APPENDIX B
POST-DR II DESIGN CHANGES

Oregon Square
November 5, 2015

CAMPUS COMMENTS TO ADDRESS - POST DR II

90-A Previous - Wall Section of West Elevation

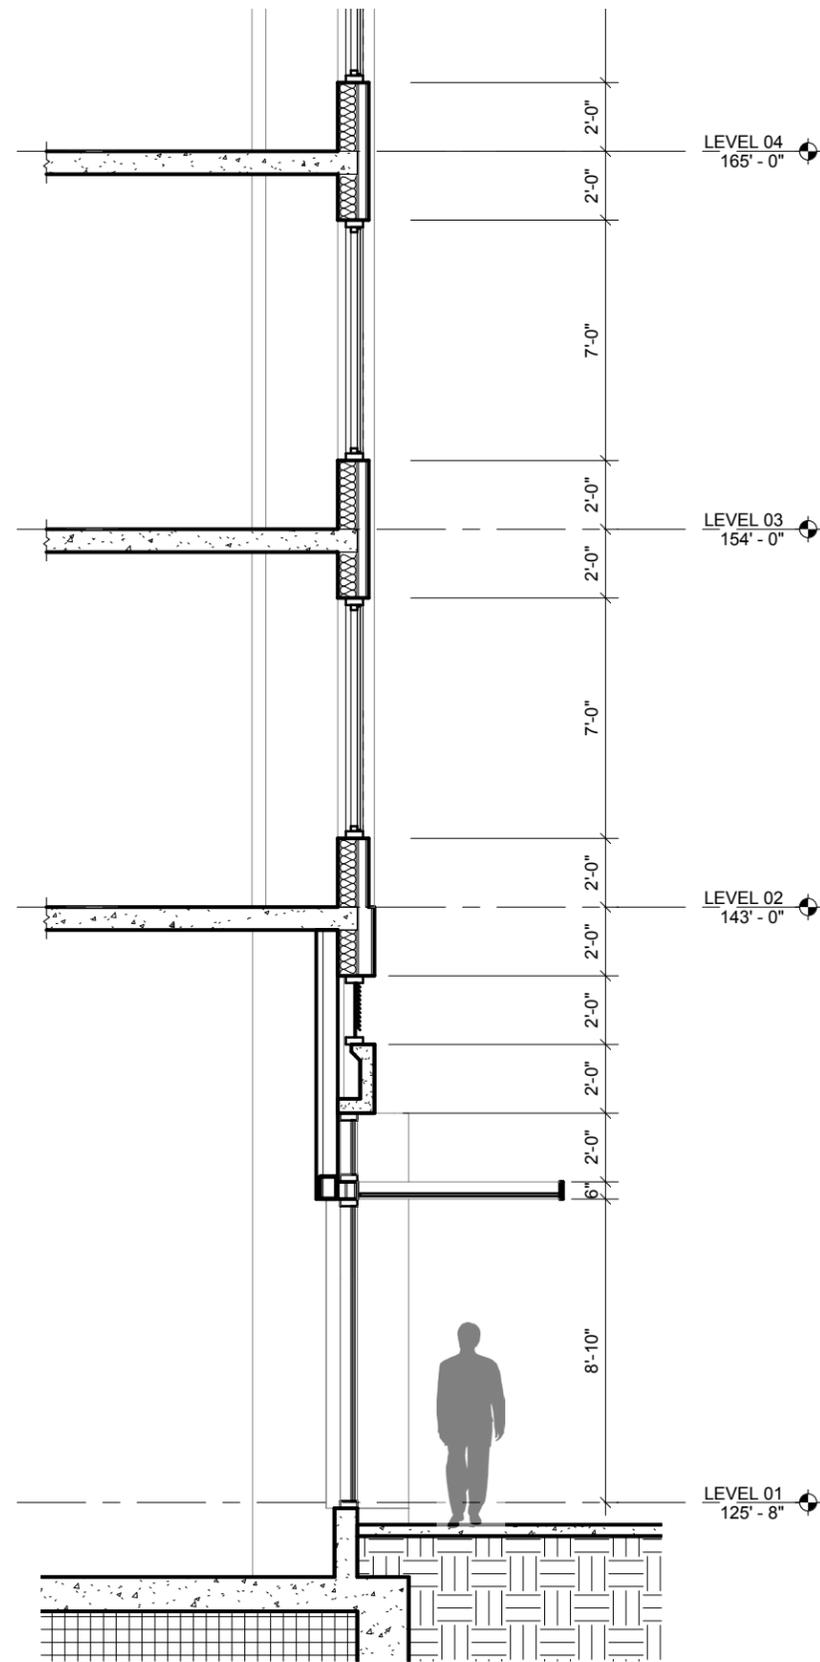
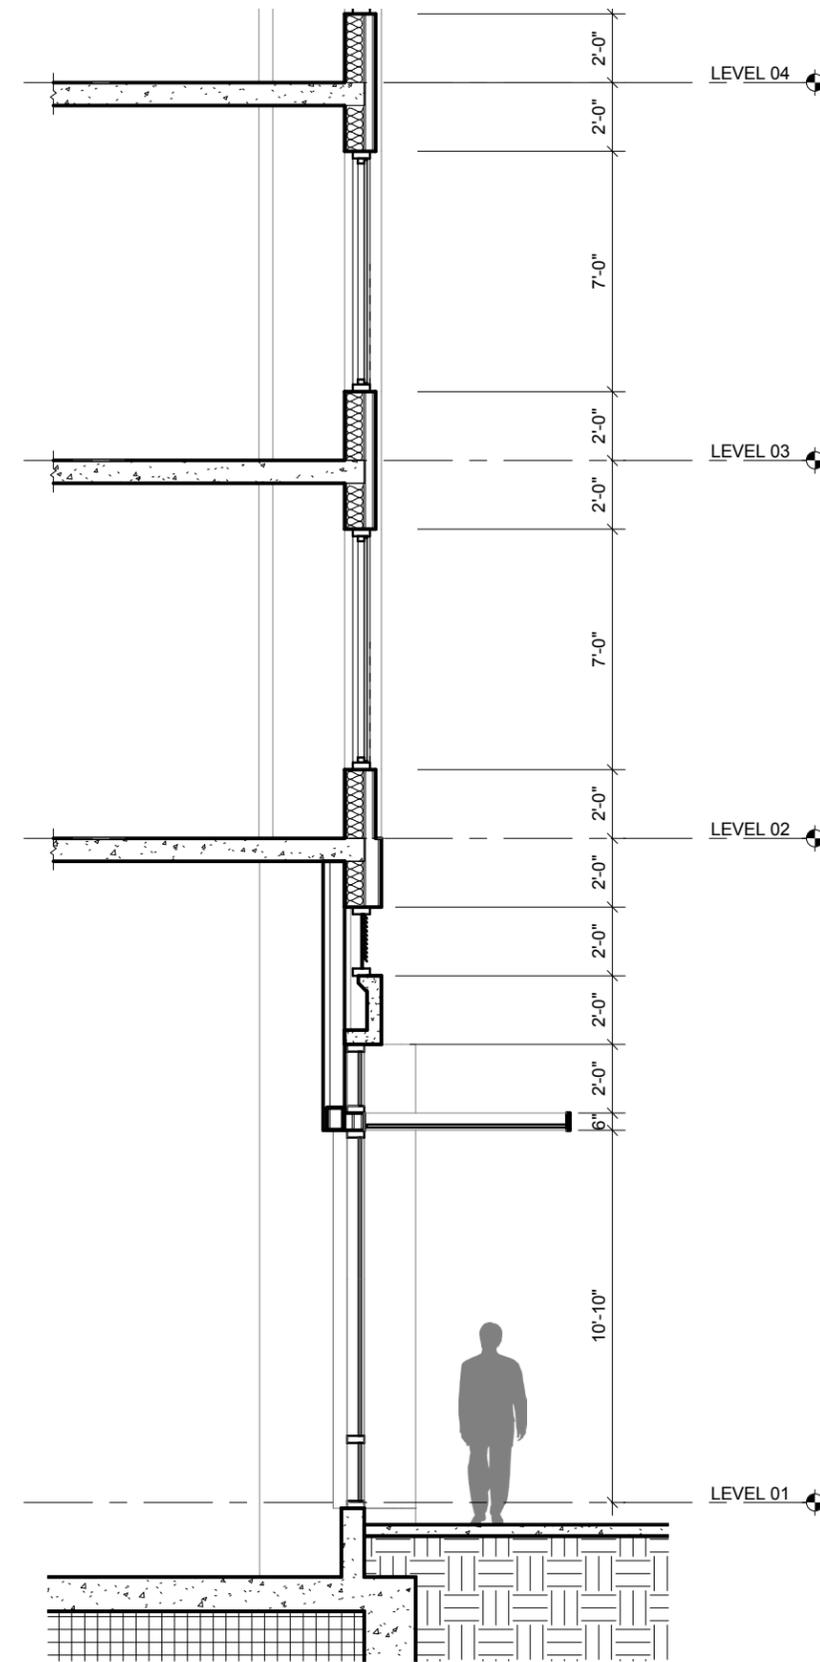
Try to get 2-3' more height on the ground floor to better reflect the typical tower condition in the district (towers atop a glass ground floor that is taller and setback).

GBD: We have added 2' to the ground floor of Bl. 90.

ENTRY/PODIUM STUDIES - BL. 103

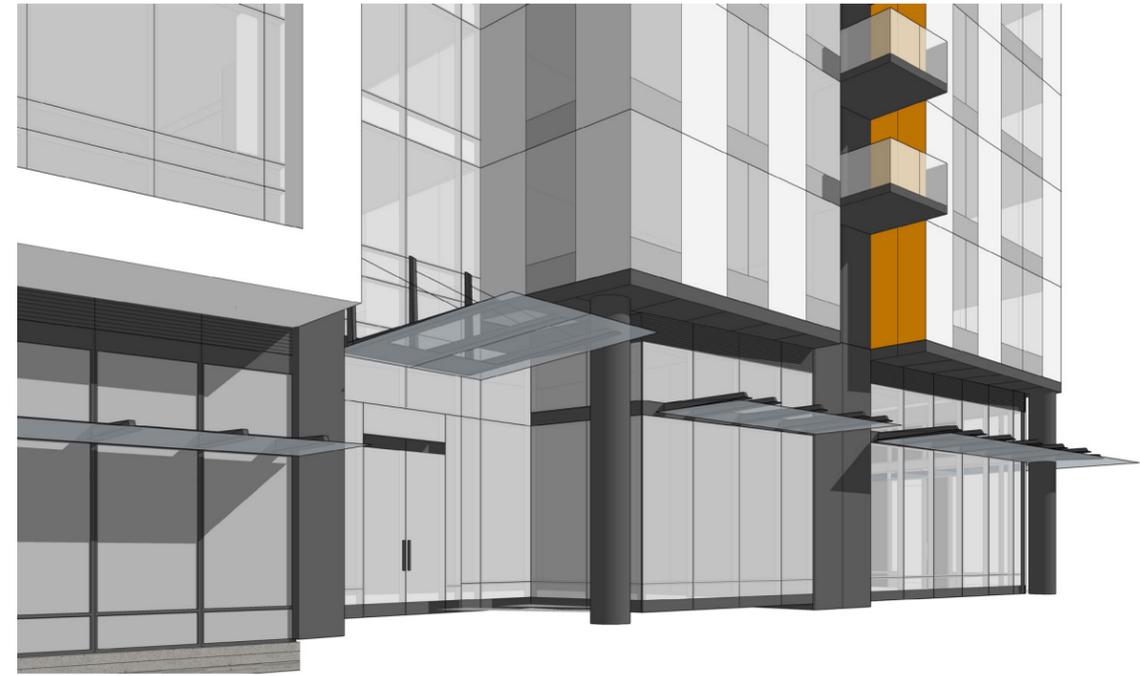
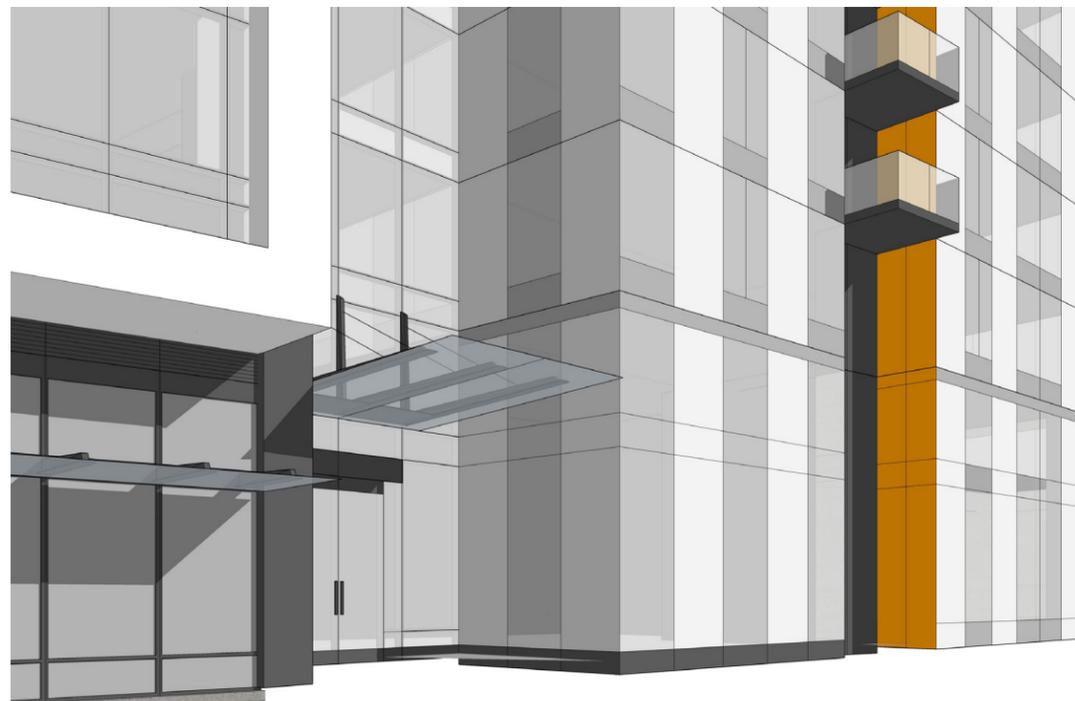
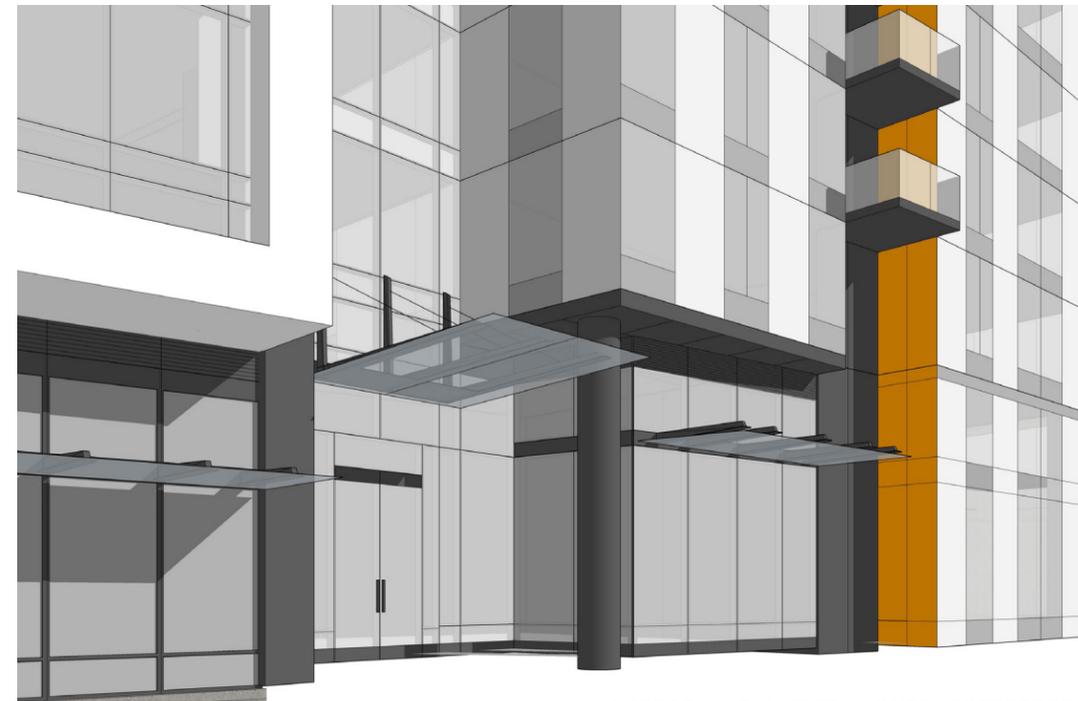
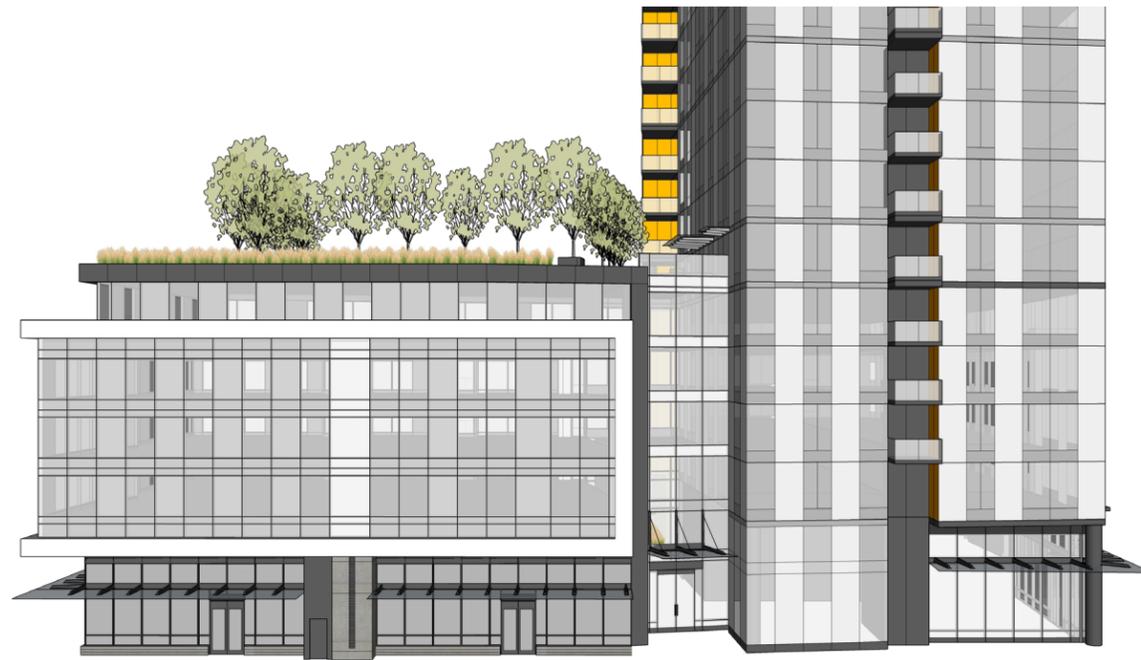
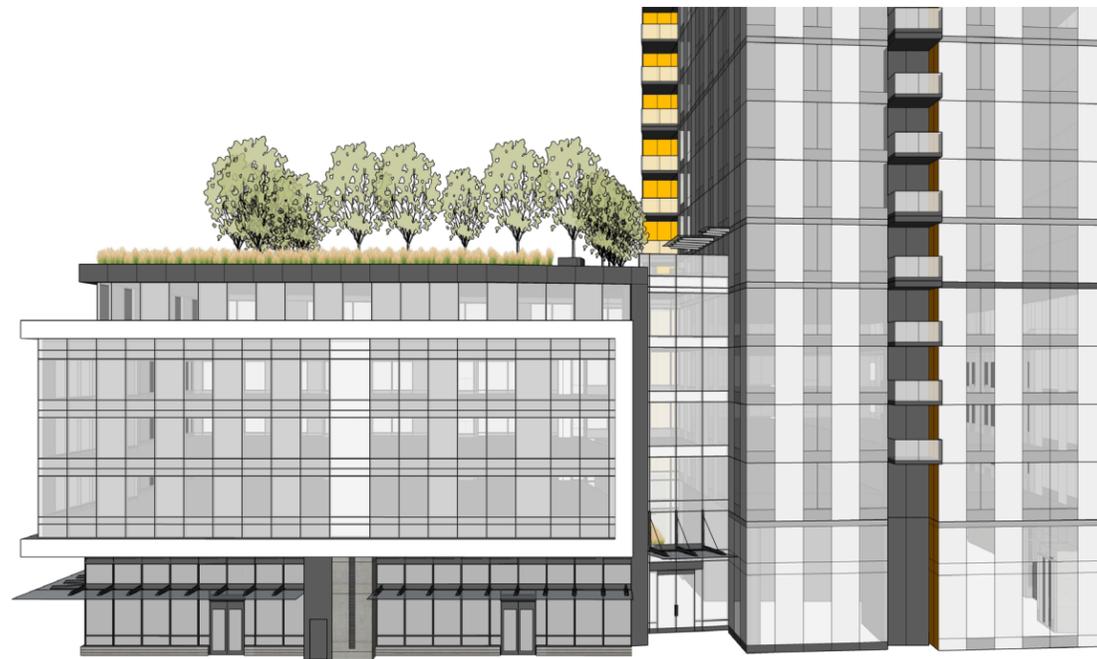
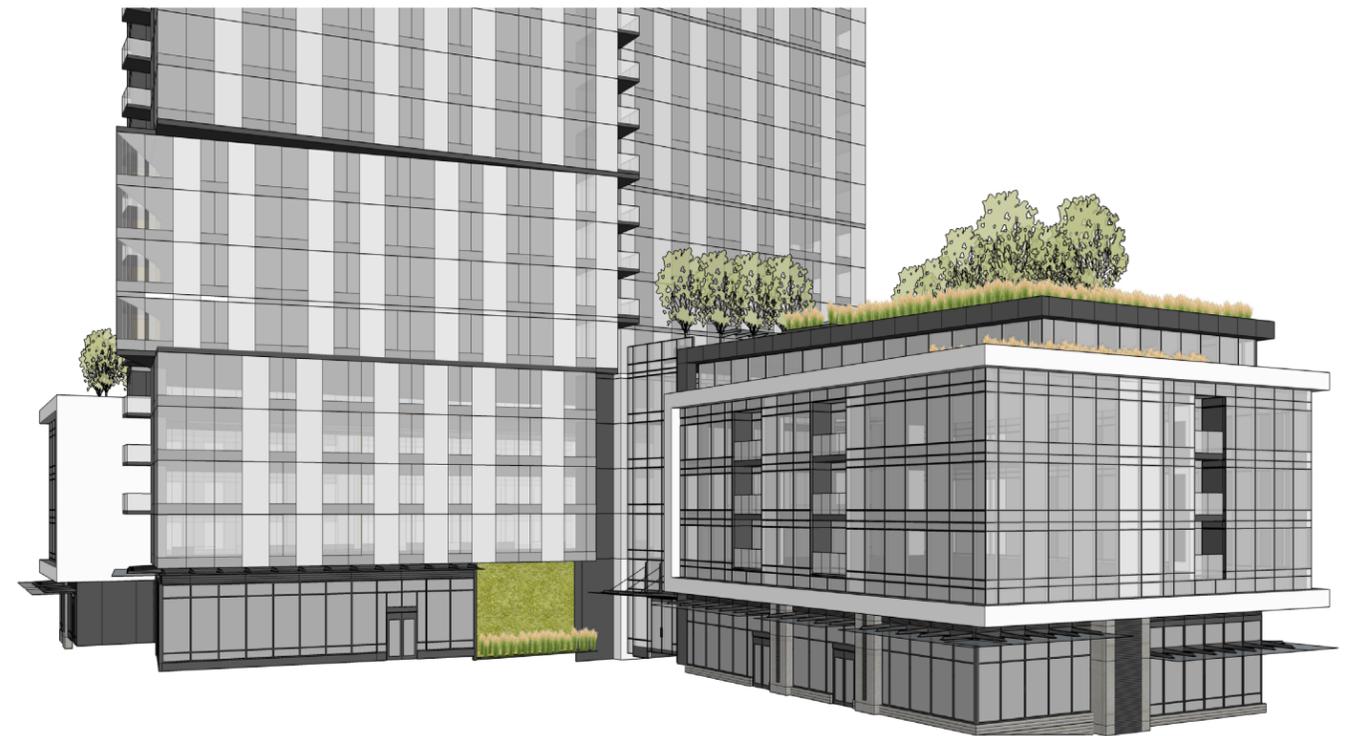
One more pass on how the podium meets the tower at the Southeast corner.

Main building entry is still constricted. Feels forced and tortured.

GBD: Studying the corner and the entry holistically.

GBD: Studying the corner and the entry holistically.

AMENITY DECK TERRACE - BL. 103

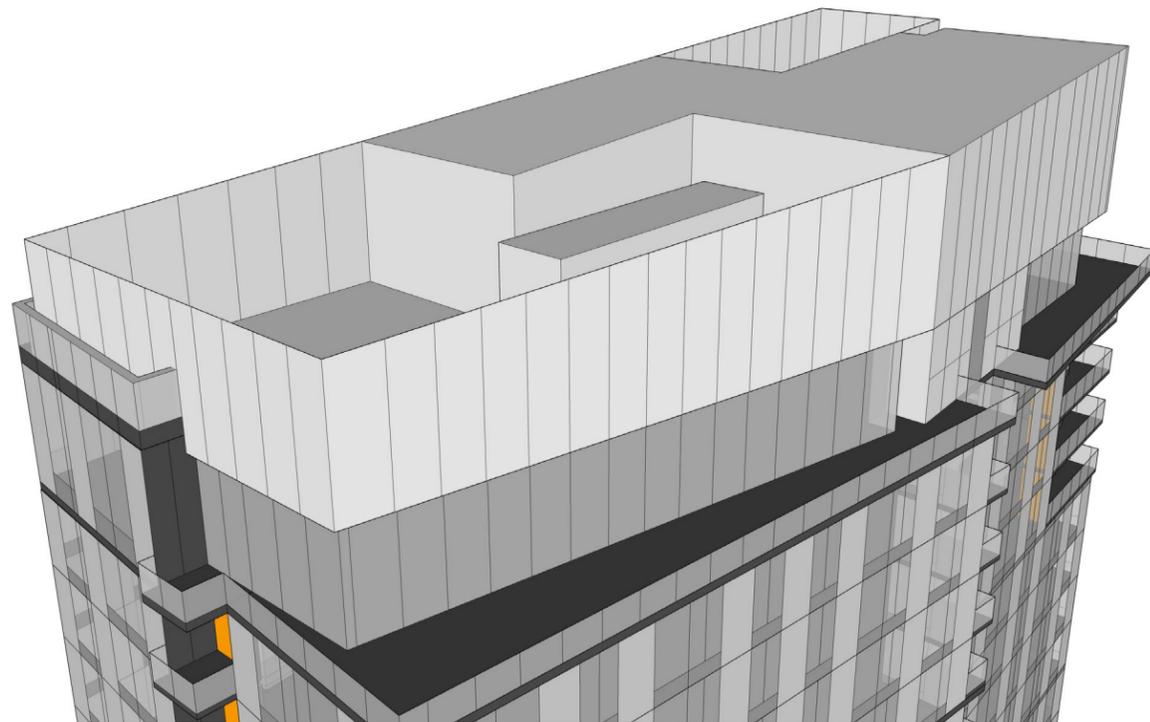
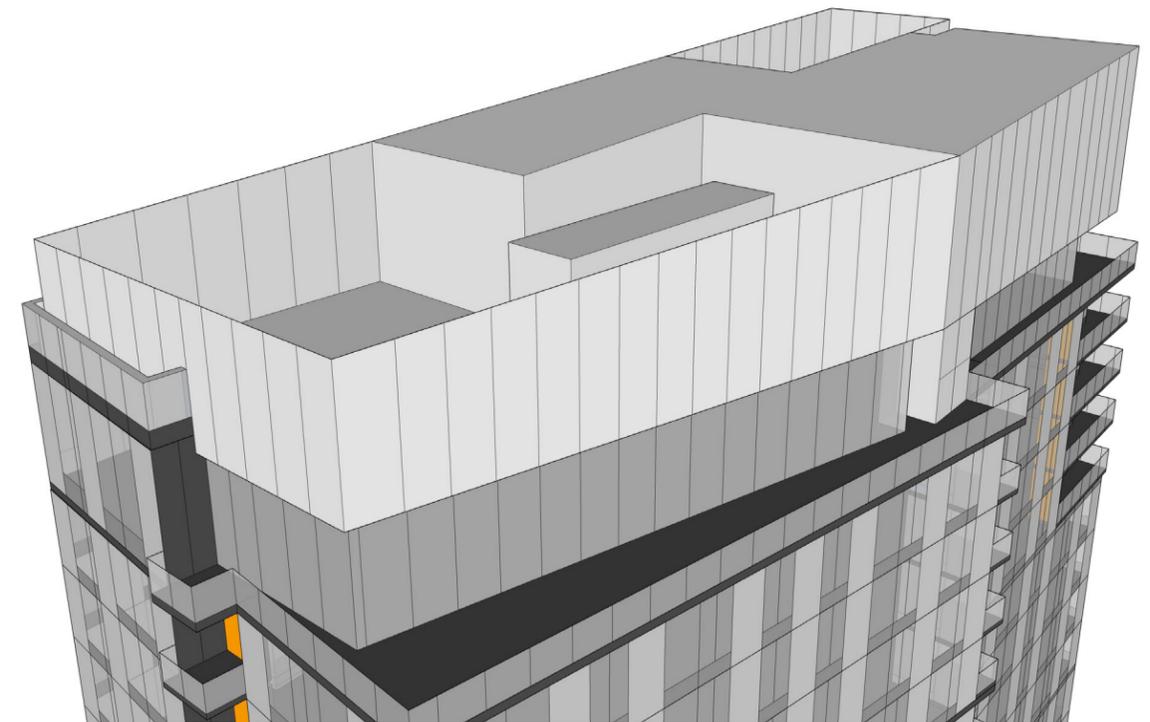
Look at amenity deck terrace on West end. Suck in to be in alignment with revised balcony.

This vignette shows the amenity deck terrace of Bl. 103 in its current form, now in plane with the terraces below. The glazing of the amenity level has been moved back in this case to make the amenity terrace still occupiable.
